# NOTICE OF DECISION

**MINOR HISTORIC DESIGN REVIEW CASE NO.: HIS21-03**

**SUMMARY:** A proposal to install a ductless heat pump system on the exterior of the Weller-Schramm House (c. 1895).

**HISTORIC DESIGN REVIEW CASE NO. HIS21-03  
DECISION**

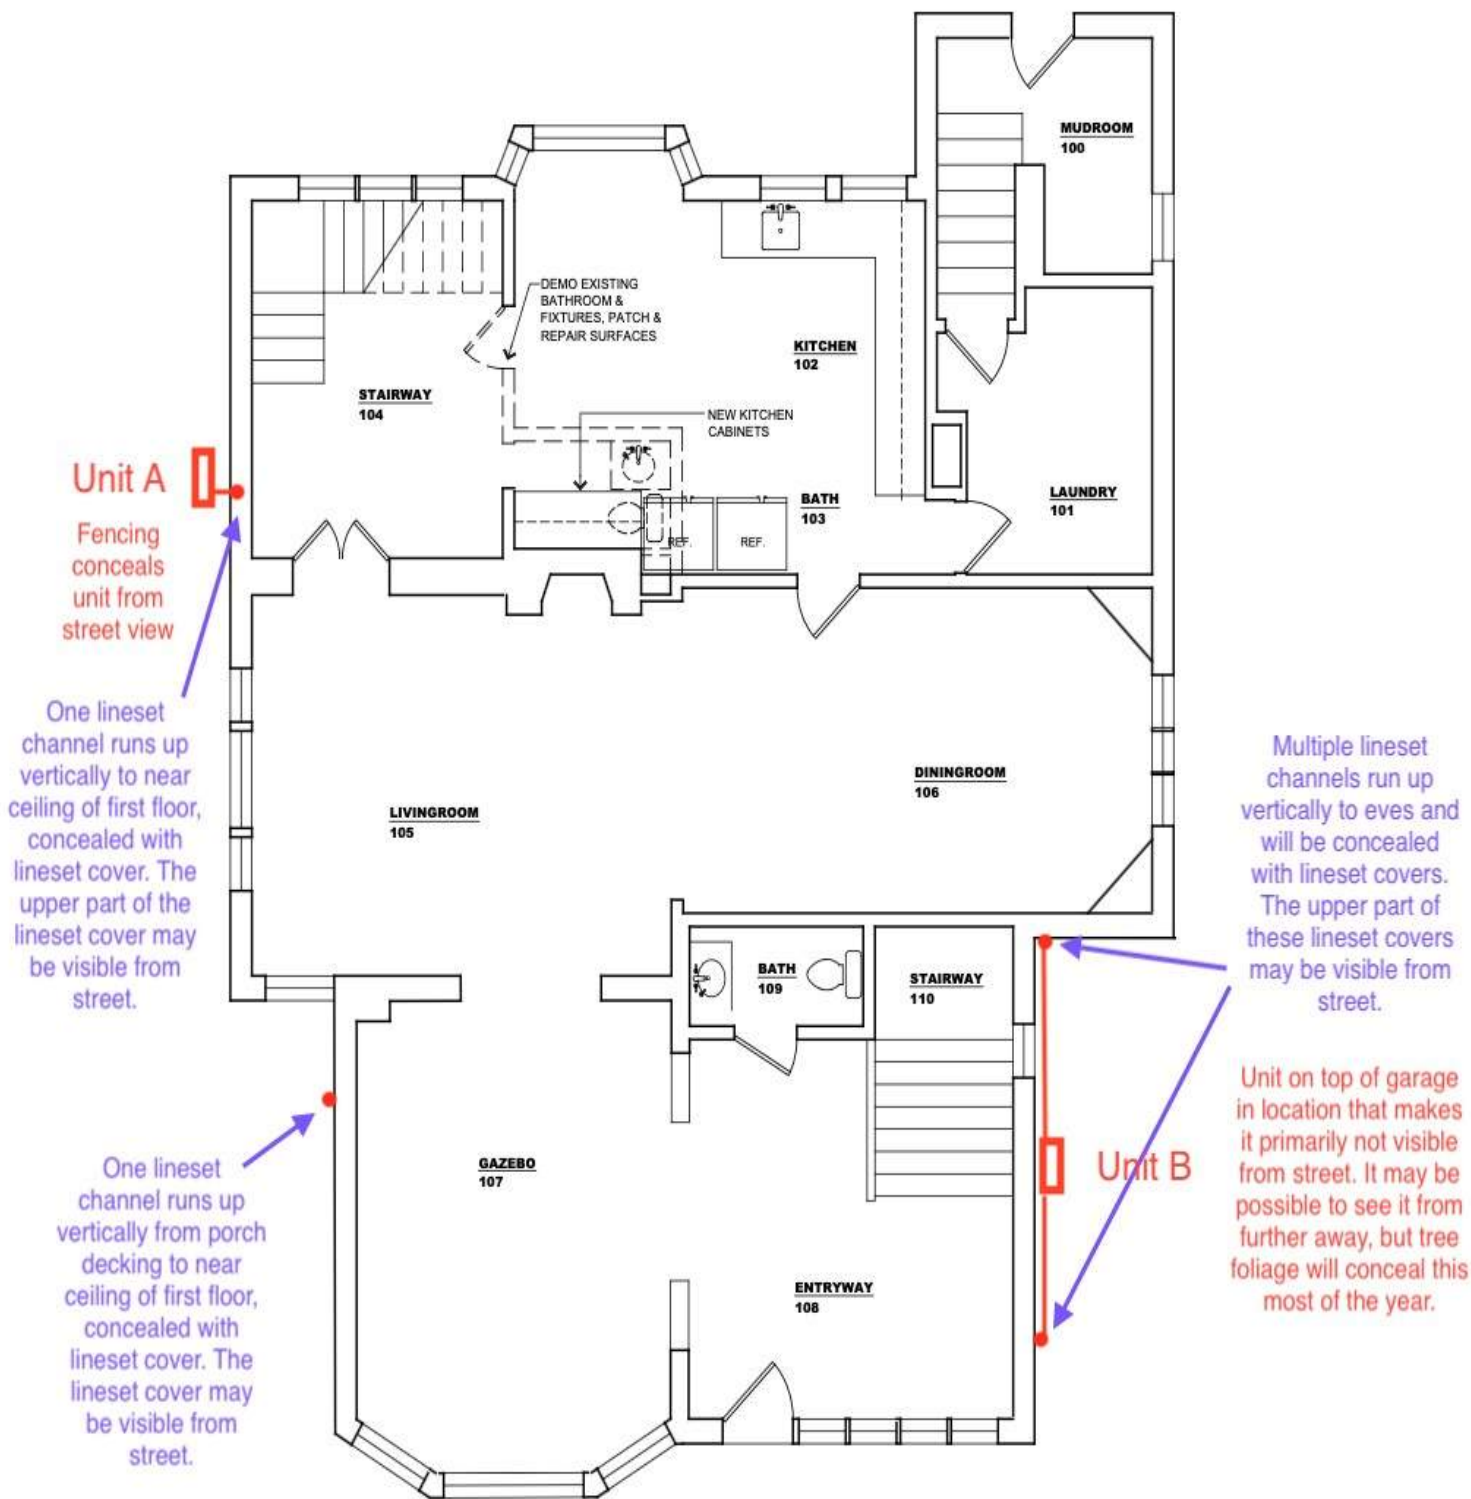
Install two ductless heat pumps in locations that are not visible or partially visible from the street. Linesets will be run inside of the house as much as possible to minimize exterior changes. There will be four lineset channels necessary on the outside of the home to make this happen. The south unit (A) will be on the ground concealed by a fence. One channel will run up the wall only as high as the first floor ceiling. The upper part of this channel may be visible from the street. Another lineset will come from under the south porch and go up the south wall of house to porch ceiling. Part of it may be visible from the street. The North Unit (B) will be on top of the garage and will be difficult to see from the street. The angle of view plus tree foliage will conceal it. Two lineset channels going up to the eaves will be visible.
